Access Compliance Report

Public Rights-of-Way

Intersection ID: 10015698	Main Street: N_BREVARD_ST	Cross Street: N/A	Location: N
ADA ID: 71BA13CC8877	Ramp Type: Perp	Initial Pass/Fail: Fail	Overall Compliance: No
		Severity Score: 12.5

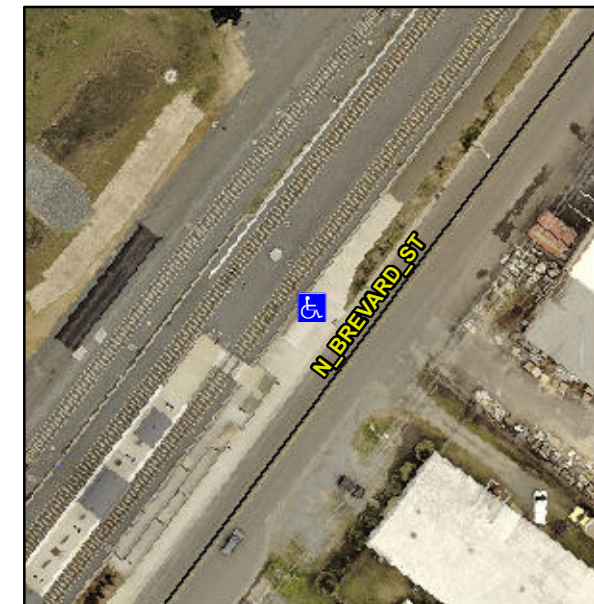
R304.2.2

Compliance	Description	Data	Compliance	Description	Data
N/A	Ramp Length (in)	97.0	No	Ramp Slope (%)	8.6
Yes	Ramp Width (in)	48.0	Yes	Ramp XSlope (%)	1.6
N/A	Flare Type LT	N/A	N/A	Flare Type RT	N/A
N/A	Flare Slope LT (%)	N/A	N/A	Flare Slope RT (%)	N/A
N/A	Flare Traversable LT?	N/A	N/A	Flare Traversable RT?	N/A
N/A	Landing Length (in)	N/A	N/A	DWS Provided?	N/A
N/A	Landing Width (in)	N/A	N/A	DWS Contrast?	N/A
N/A	Landing Slope (%)	N/A	N/A	DWS Length (in)	N/A
N/A	Landing X Slope (%)	N/A	N/A	DWS Full Width?	N/A
N/A	Landing Curb? (Y/N)	N/A	N/A	DWS Offset (in)	N/A
N/A	Shared Landing?	N/A			
N/A	Gutter Ponding?	N/A	N/A	Gutter Slope (%)	N/A
N/A	Gutter Lip Ht (in)	N/A	N/A	Gutter X Slope (%)	N/A
N/A	Painted X Walk1?	No	N/A	Painted X Walk2?	N/A
	X Walk 1 Direction	To S		X Walk 2 Direction	N/A
N/A	X Walk 1 Width (in)	N/A	N/A	X Walk 2 Width (in)	N/A
	X Walk 1 Slope (%)	5.2		X Walk 2 Slope (%)	N/A
	X Walk 1 X Slope (%)	0.1		X Walk 2 X Slope (%)	N/A

Remove & Replace Entire Ramp.
